Owner Change Order

Change Order Number: 003

City of Norman - North Base Complex Phase 1
1310-1380 DA Vinci Street
Norman, Oklahoma 73069

The Contract is hereby revised by the following items:

SHEET NUMBER
C4.0

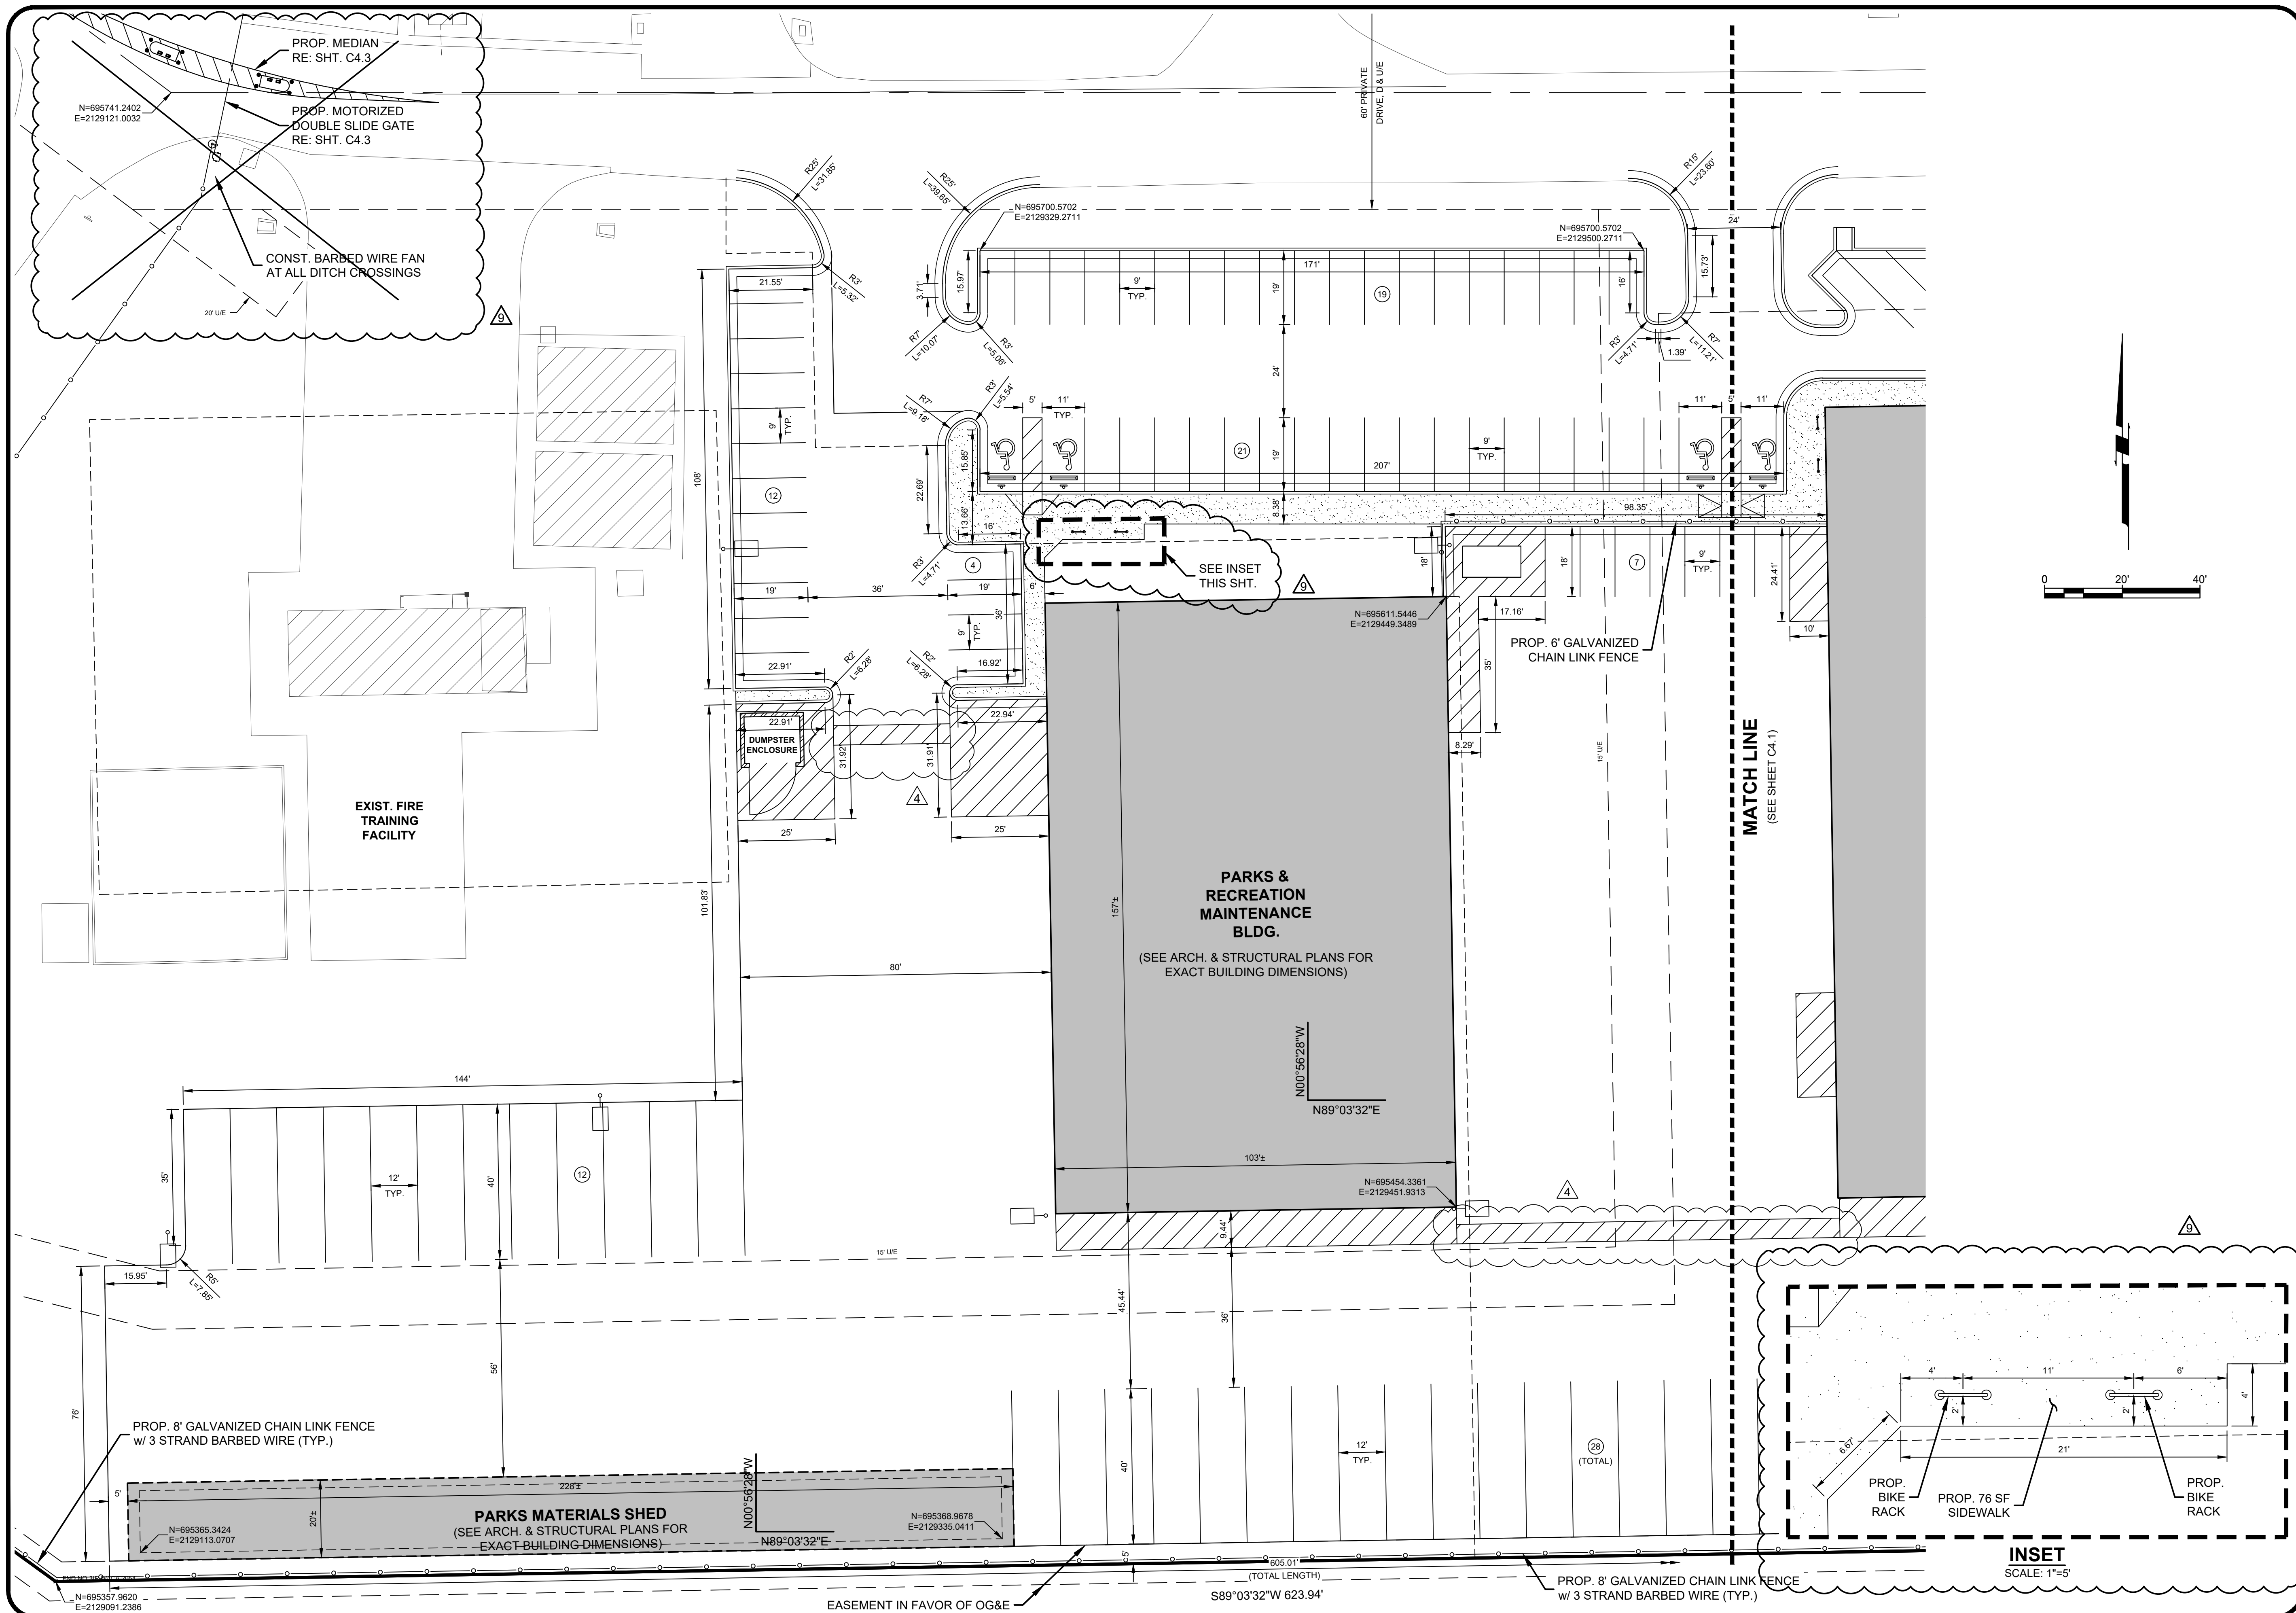
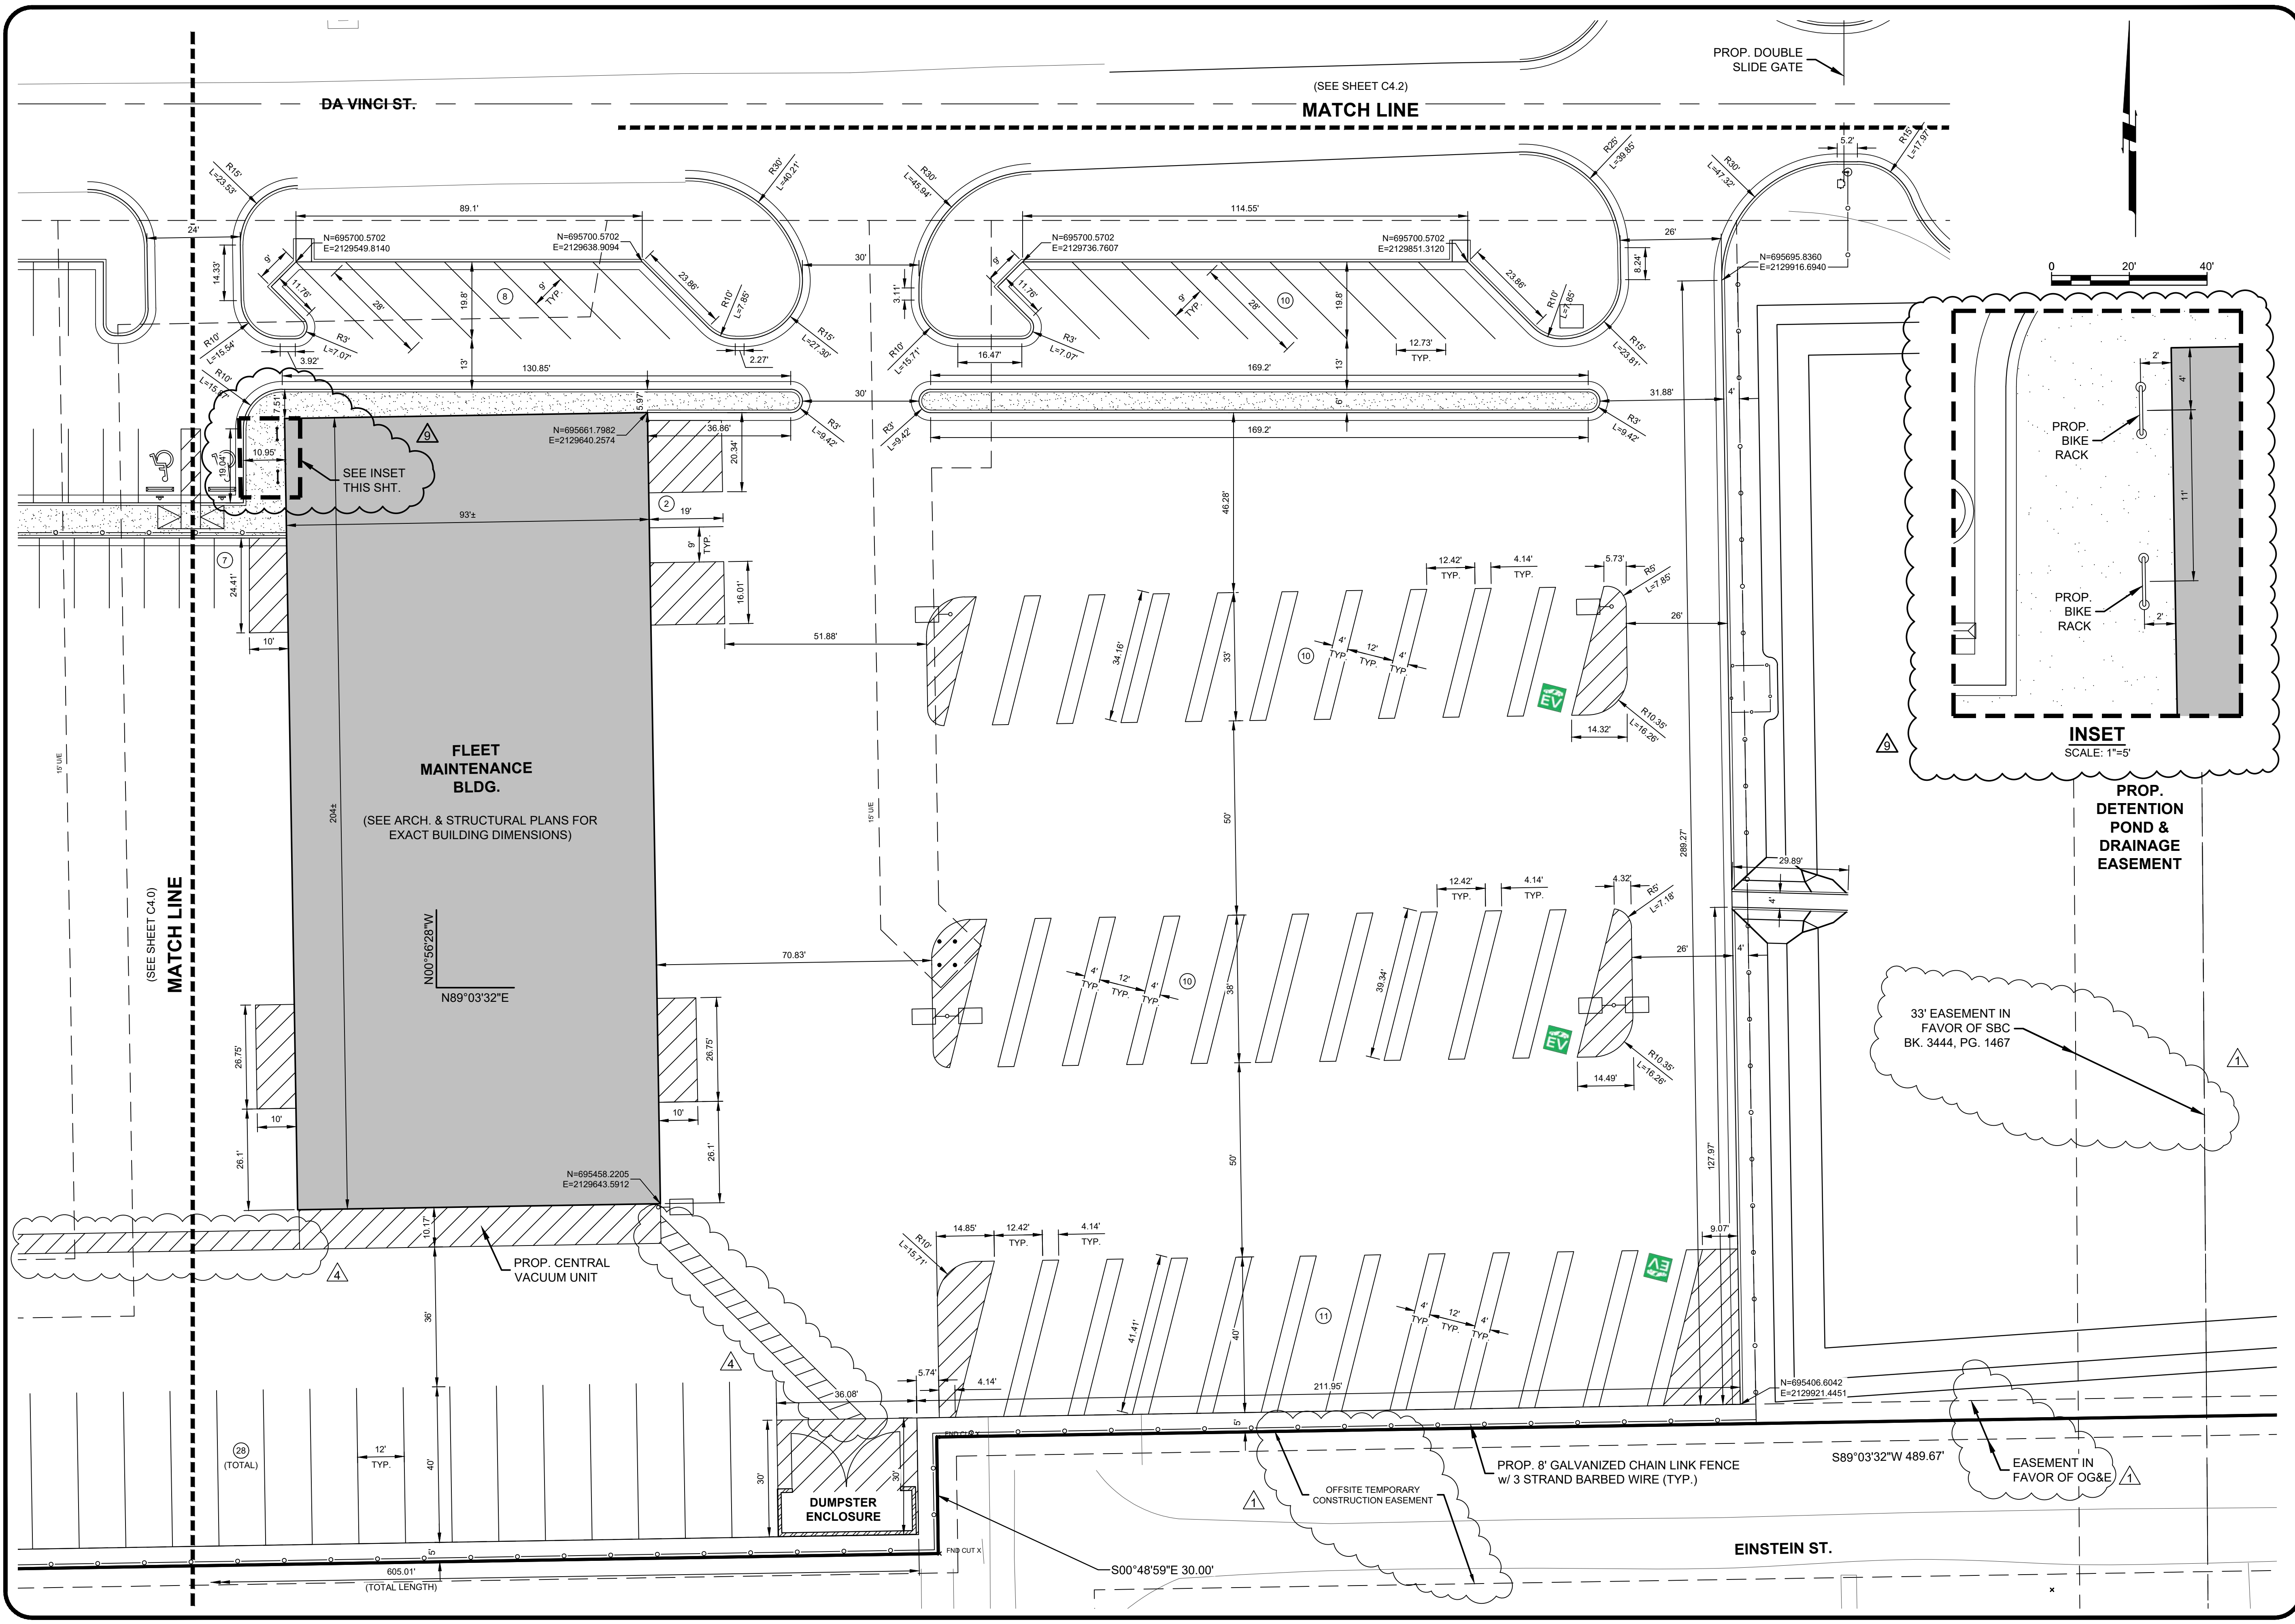
- Add 4" thick sidewalk paving to accommodate bike rack per revised SH C4.0
- Add 7" NR PC Paving per added SH C4.4 and detail C5.0
- Add 32" Curb and Gutter adjacent to new PC paving per added SH C4.4
